Final Product/Process Change Notification

Document #:FPCN27309X

Title of Change:	Additional Assembly and Test Site for QDual3 IGBT Package at Shenzhen, China.			
Proposed First Ship date:	15 Aug 2026 or earlier if approved by customer			
Contact Information:	Contact your local onsemi Sales Office			
PCN Samples Contact:	Contact your local onsemi Sales Office. Sample requests are to be submitted no later than 30 days from the date of first notification, Initial PCN or Final PCN, for this change. Samples delivery timing will be subject to request date, sample quantity and special customer packing/label requirements.			
Additional Reliability Data:	Contact your local onsemi Sales Office			
Type of Notification:	This is a Final Product/Process Change Notification (FPCN) sent to customers. FPCNs are issued 90 days prior to implementation of the change. onsemi will consider this change accepted, unless an inquiry is made in writing within 30 days of delivery of this notice. To do so, contact PCN.Support@onsemi.com

onsemi Shenzhen, China marking style:

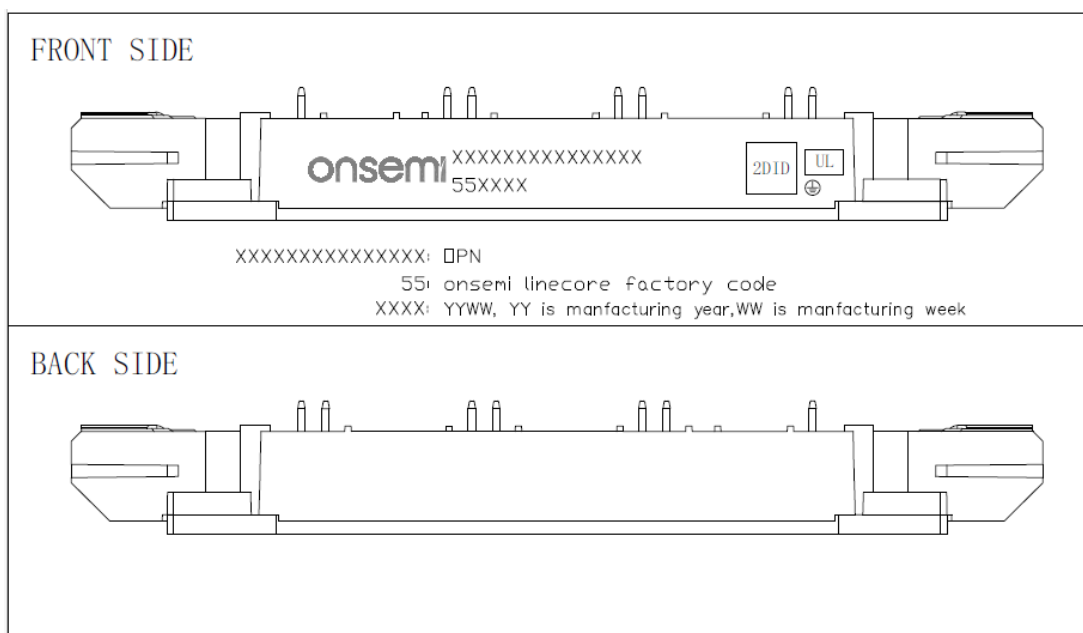
Marking of Parts/ Traceability of Change:	Product from new added site can be identified by lot code and marking.			
Change Category:	Test Change, Assembly Change			
Change Sub-Category(s):	Manufacturing Site Addition			
Sites Affected:				
onsemi Sites		External Foundry/Subcon Sites		
onsemi Shenzhen, China		None		
Description and Purpose:				
onsemi wishes to inform customers the qualification of onsemi Shenzhen, China (ONSC) as an additional assembly and test site for PIM QDual3 IGBT Package products with onsemi Shenzhen, China (ONSC) qualified materials.				
onsemi Shenzhen, China (ONSC) and Linecore are using different marking styles, product from ONSC can be identified by marking.				
	Before Change Description	After Change Description		
Assembly Site	Linecore	onsemi Shenzhen, China Linecore		
Test Site	Linecore	onsemi Shenzhen, China Linecore		
Product marking change	Linecore making style	onsemi Shenzhen, China marking style Linecore making style

Take NXH800H120L7QDSG as example, SNXH800H120L7QDSG marking will be similar.				
Site	onsemi Shenzhen, China		Linecore	
Front side	OPN:	NXH800H120L7QDSG	OPN:	NXH800H120L7QDSG
	Trace code:	\A\T/(YYWW)	Trace code:	\A\T/(YYWW)
	Frontside 2DID:	NXH800H120L7QDSG (YYWW)\A\T/	Frontside 2DID:	NXH800H120L7QDSG\A\T/(YYWW)(ZZZZZZZZ)(NNNNNNNN)(+)(+)(+)

Back side	Backside 2DID:	(ZZZZZZZZZZ)(+)(NNNNNNNN)	Backside 2DID:	NA
-----------	----------------	---------------------------	----------------	----
